RITZ-CARLTON PARADISE VALLEY

**Town Council Study Session
November 19, 2015**

Residential lot size (attached)

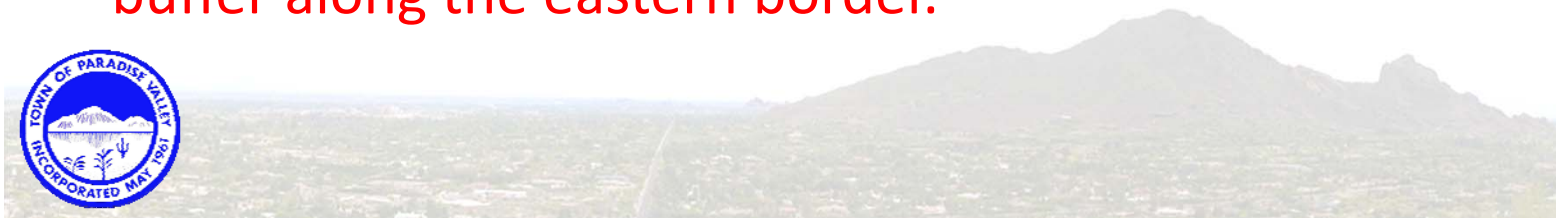
- Attached residential product as proposed is disfavored and alternate uses for Area D shall be explored.
- With the exception of the resort lobby, it is recommended that all four-story/48' tall elements be eliminated and three-story/36' maximum height be considered for principal structures only, and as a buffer along the eastern border.

Residential lot size (detached)

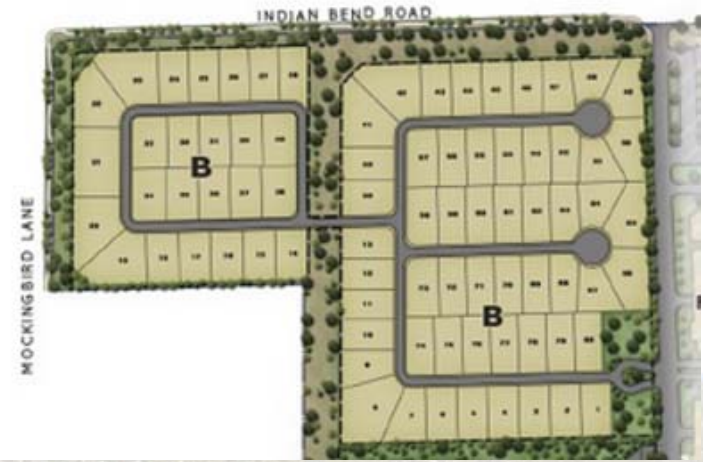
Recommend that all detached residential product in Areas B and C:

- Have an average of two dwelling units per acre, and
- Progress from larger lots on the north, south, and west perimeters to more dense lots in the center and eastern perimeter.
- Detached residential product shall be a mix of 1 and 2 story.
- Setbacks shall be proposed in a Land density table for all lot types

Rights-of-Way/Traffic/Parking (cont.)

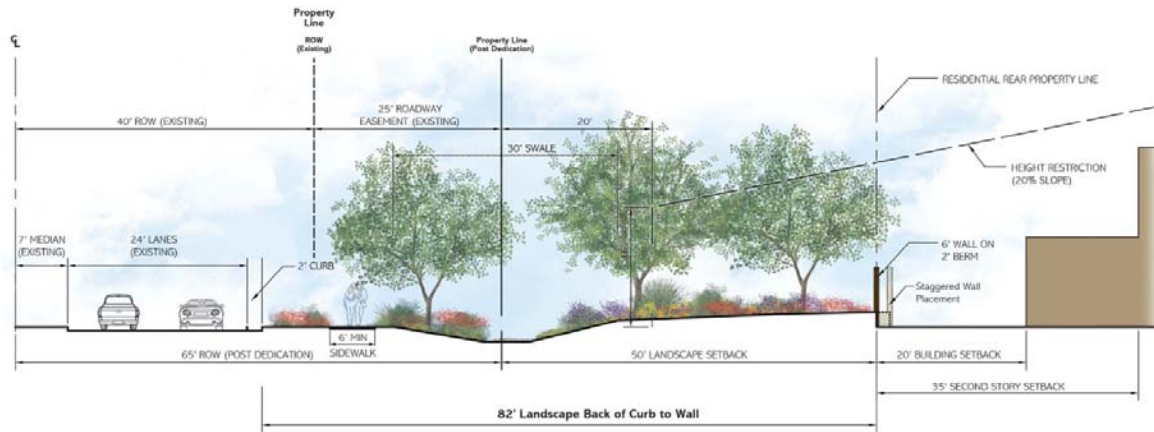
- Recommend that 25' of Right of Way (ROW) dedication be required along Lincoln Drive. This differs from the 2008 SUP that allowed for a roadway easement. The 2012 General Plan has now categorized Lincoln Drive as a Visually Significant Corridor and dedication is requested to allow for development of Lincoln Drive as a Visually Significant Corridor and as a Gateway to the Town. The applicant shall identify setbacks from the post-dedication property line.

Additional Review Items (cont)

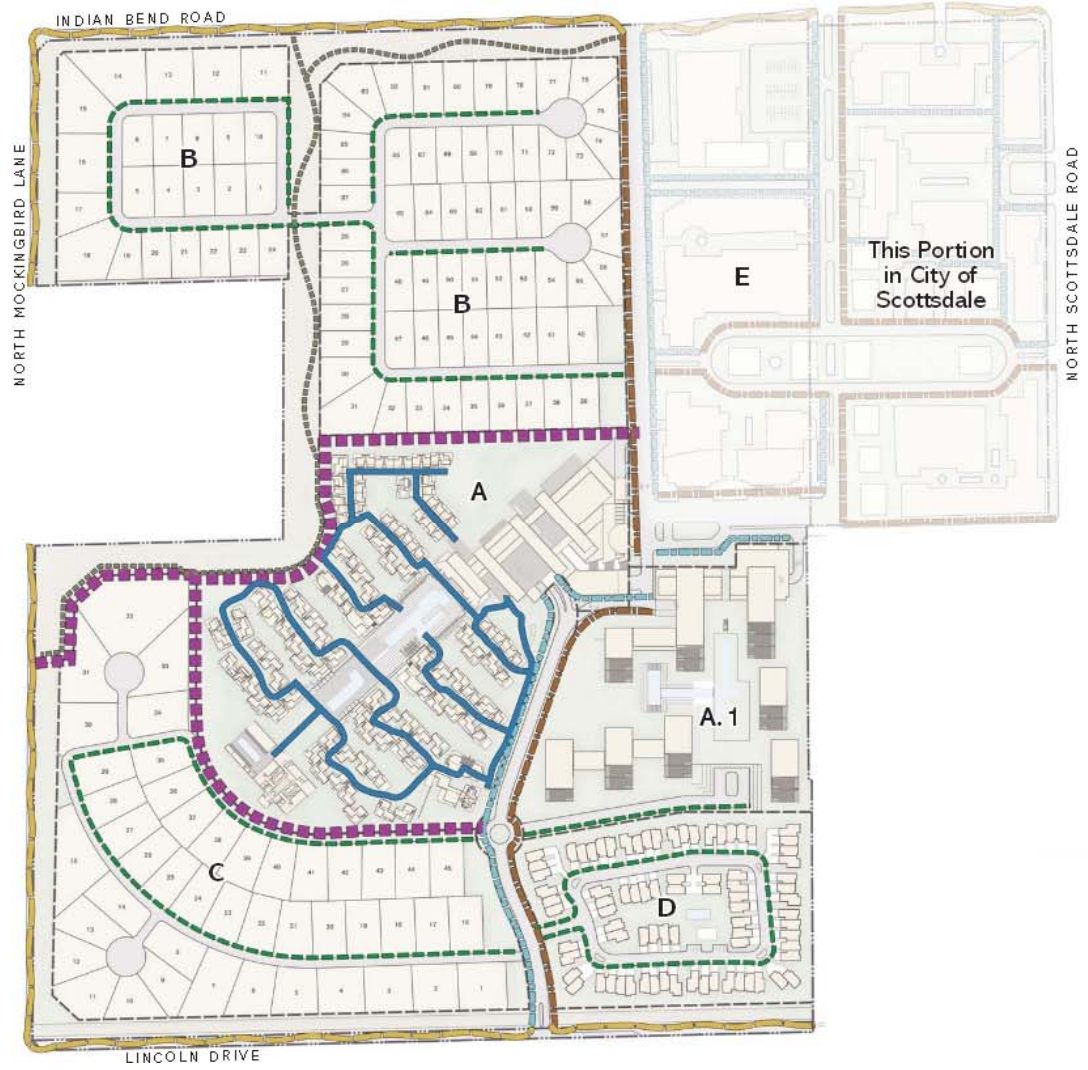
- Any necessary upgrades for potable water supply shall be explored.
- Pedestrian and non-vehicular circulation shall be reviewed.

Additional Review Items (cont)

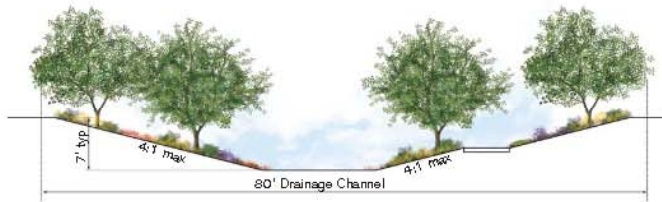
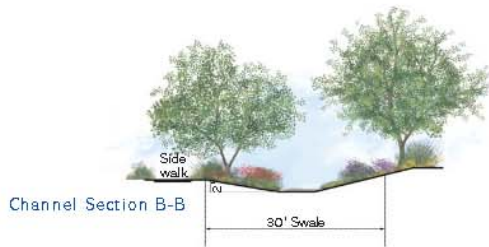
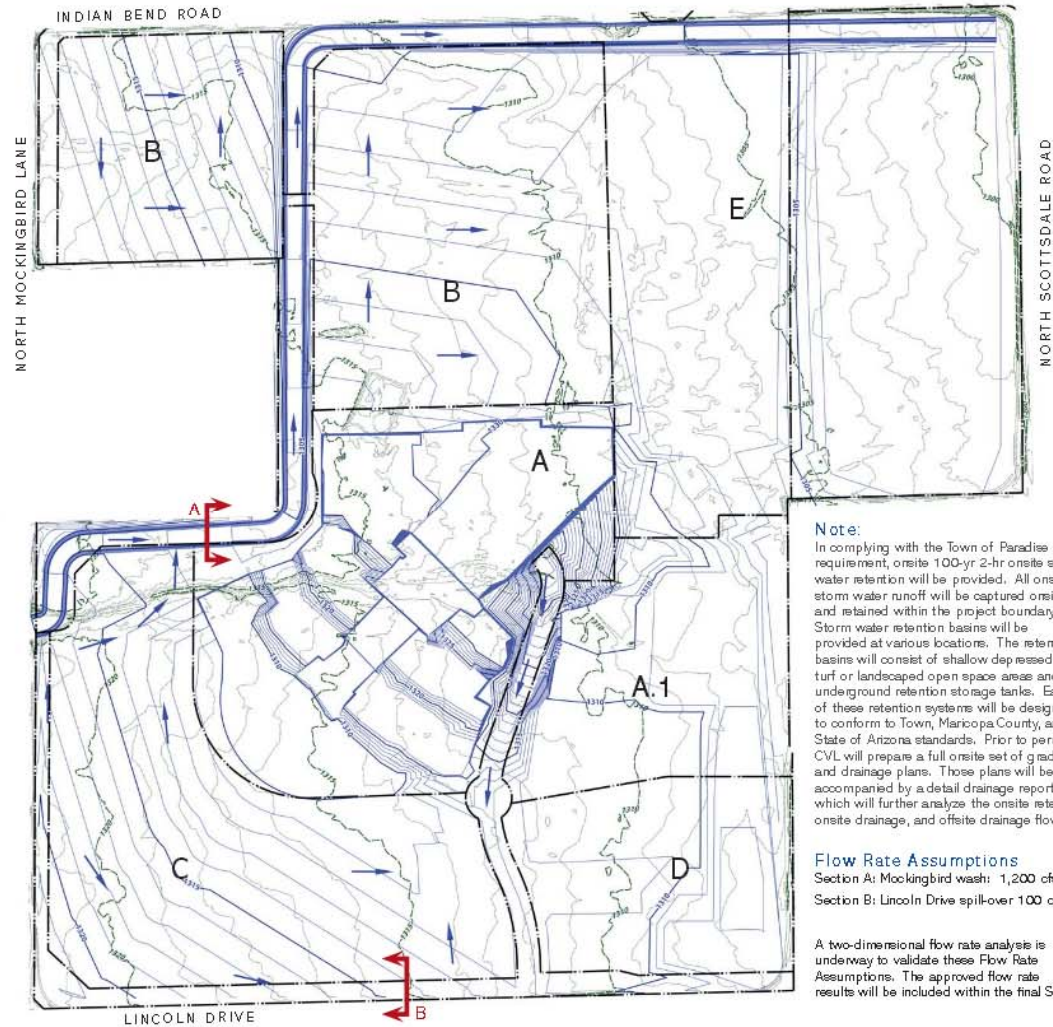
- Recommend that the Commission utilize a Town hired third-party engineer to review the grading and drainage study prepared by the applicant with emphasis on the necessary retention requirements and the proposed rerouting of the natural wash. A detailed grading and drainage plan for the site will need to be provided that is in conformance with the most current version of the Town of Paradise Valley Storm Drain Design Manual – Subdivision Drainage Design at time of permit submittal.

Note:
 In complying with the Town of Paradise Valley requirement, onsite 100-yr 2-hr onsite storm water retention will be provided. All onsite storm water runoff will be captured onsite and retained within the project boundary. Storm water retention basins will be provided at various locations. The retention basins will consist of shallow depressed turf or landscaped open space areas and underground retention storage tanks. Each of these retention systems will be designed to conform to Town, Maricopa County, and State of Arizona standards. Prior to permit CVL will prepare a full onsite set of grading and drainage plans. Those plans will be accompanied by a detail drainage report which will further analyze the onsite retention, onsite drainage, and offsite drainage flows.

Rights-of-Way/Traffic/Parking

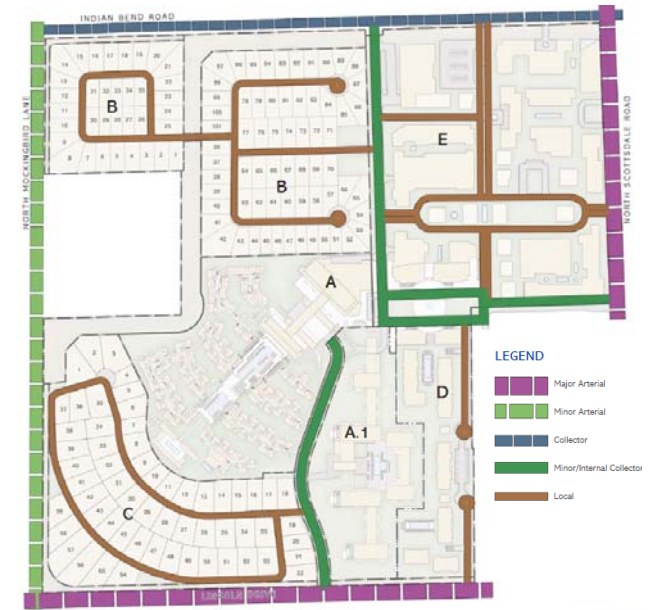
- All roadway amenities such as sidewalks, medians, round-a-bouts, deceleration lanes, and traffic/pedestrian signals shall be reviewed and designed to meet Town Engineering Department standards.
- Traffic and Parking Study shall be reviewed.
